Plan Commission recommendation to approve a Map Amendment and Final Plat of Subdivision for Parkside Reserves, 1337 Geneva Rd.

**A Resolution Recommending Approval of a Map Amendment and Final Plat
of Subdivision for Parkside Reserves, 1337 Geneva Rd.
(Grandview Capital, LLC)**

Staff Report

RE: Parkside Reserves – 1337 Geneva Rd.

FRONT ELEVATION
 SCALE: 1/4" = 1'-0"

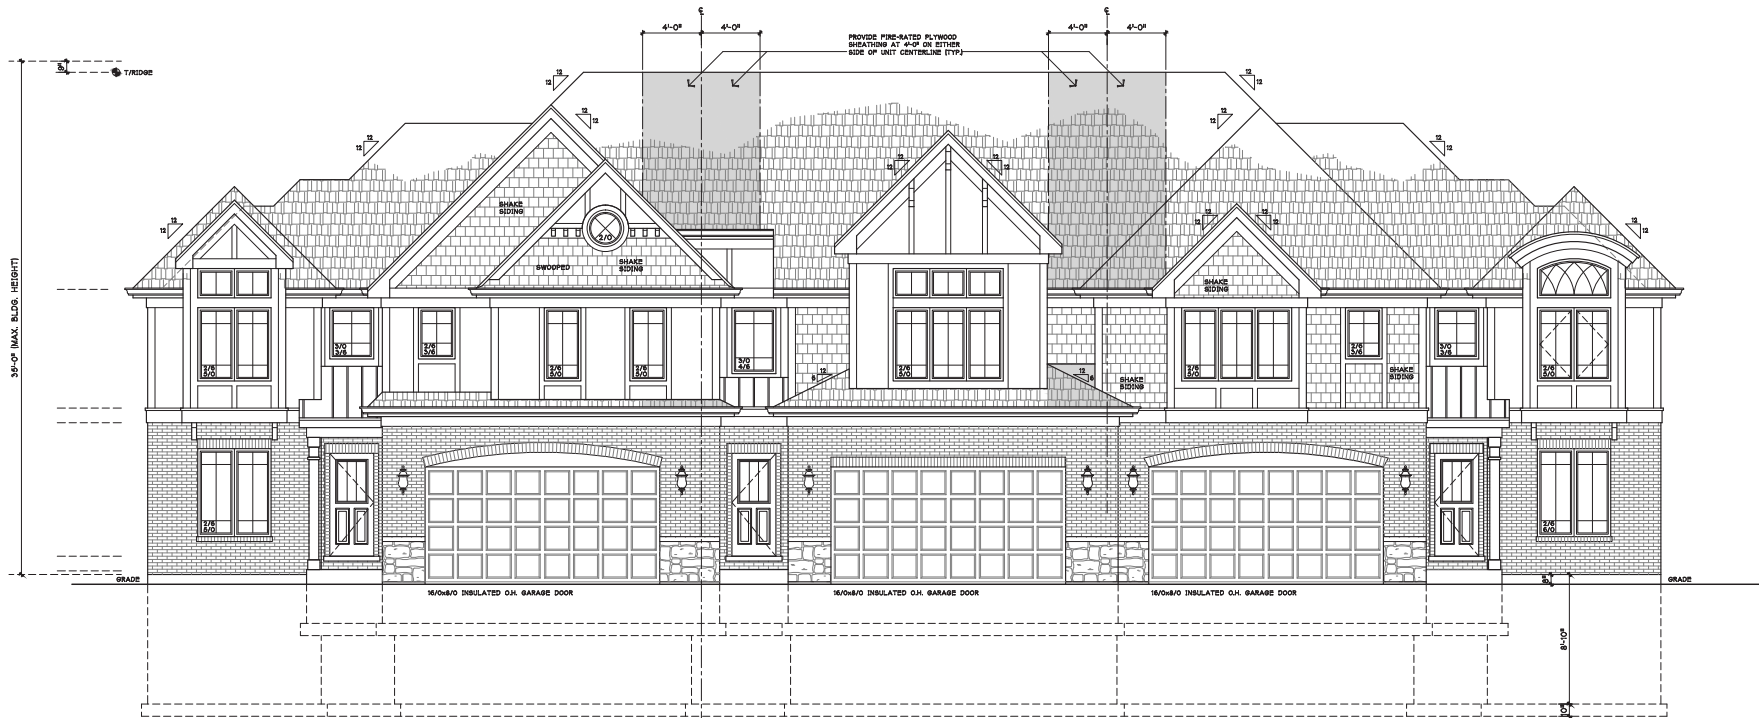
- Per the Zoning Ordinance, building height is measured as the vertical distance from grade at the midpoint of the required front building setback to the top of the ridge of the highest point of the roof. The building height is marked on the architectural elevations as just under 35 ft. However, grade at the midpoint of the front building setback (30 ft.) is approximately 3 ft. lower than grade at the building foundation, meaning the building height is greater than 35 ft. The building will need to be modified to meet the height limitation.
